Reviewer 1

The comments of Reviewer 1, along with our responses to each comment, are included below:

“This work presents a boundary optimal control strategy for axial tubular reactors with first-order irreversible chemical reaction incorporating a delayed recycle stream. The mathematical description takes the form of a system of coupled parabolic and hyperbolic PDEs. An infinite-dimensional approach is applied to derive a linear quadratic regulator with and without observer. Numerical studies show that the proposed controller is able to stabilize the system. The manuscript is clear and well written and addresses a challenging control problem in chemical engineering. The following comments and suggestions may improve the presentation so that it is considered for publication.”

Figure 1: Concentration profile along the recycle stream

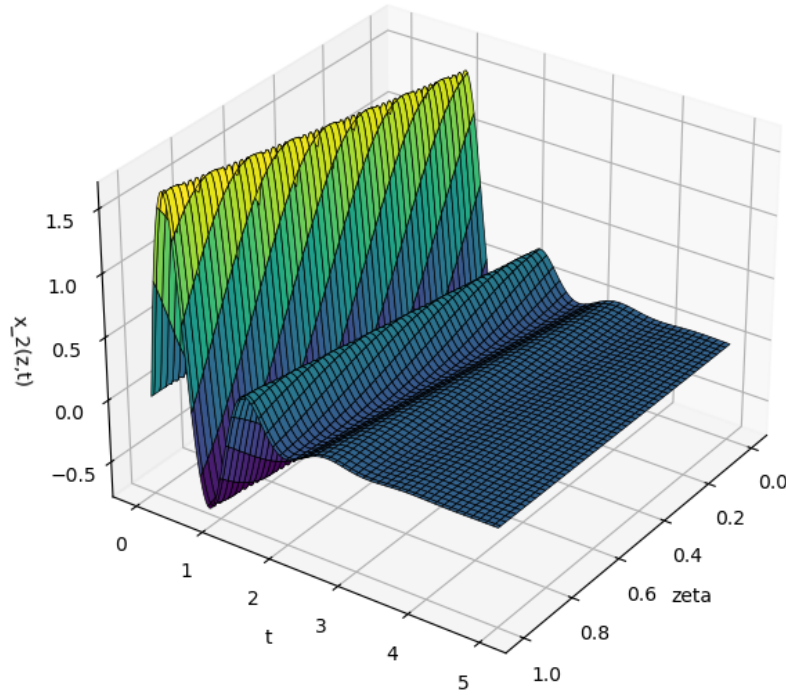
6. Page 7 - " $x_2(\zeta, t)$ is introduced as a new state variable to account for the concentration along the recycle stream"

- Why is x_2 a function of ζ ? How does x_2 change across the recycle? What kind of law does it follow? To me, it seems like x_2 only changes with respect to time

Authors Reply:

We have assumed that along the recycle stream, the flow of the reactant belongs to the class of pure transport PDEs. This is the case when the diffusion term and the reaction term become negligible compared to the convective term, and the state variable x_2 is merely being transported along the recycle stream. Nevertheless, this still implies that x_2 is a function of ζ and t . Concentration profile along the recycle stream has not been presented in the original submission as we believe it is not the focus of this work. However, for the reviewer's reference, it is included here in the response as shown in Fig. 1.

Figure 2: Axial tubular reactor with recycle stream.

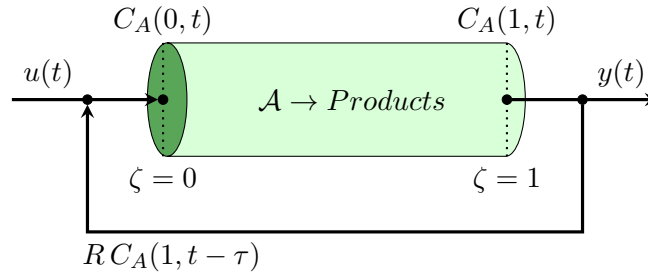
11. Page 18 - unstable dynamics of the model

- Why is the zero-input response considered unstable? Is it a qualitative assessment? What is the physical meaning of Figure 9?

We appreciate the reviewer's thoughtful questions regarding the zero-input response and its interpretation. As mentioned previously, the original submission focused on the broader goals of the study, offering a concise explanation of the proposed model. However, based on the reviewers' feedback, we recognized the need to address potential misunderstandings caused by this brevity. To address this query comprehensively, we aim to clarify the modeling approach by outlining the modeling steps and the reasoning behind the chosen framework here in the reply, as they are critical for understanding the observed instability and its implications. In addition, we have also updated the manuscript to provide a more detailed and general explanation of the model. These revisions ensure that the manuscript presents a clearer and more comprehensive framework while preserving the original model's intent and structure.

For the axial dispersion tubular reactor presented in Fig. 2, the molar balance equation may be written for the reactant concentration, C_A , as follows:

As a result, the zero-input response is considered unstable due to the positive reaction term in the model. Figure 9 illustrates the unstable dynamics of the linearized model in the vicinity of the steady-state in the absence of control input; with the qualitative assessment that a deviation from the steady state may draw the system to a different steady state, resulting in completely different model dynamics than the one used to design and control the system for optimal operation. The manuscript has been updated to include more detailed explanation in this regard.
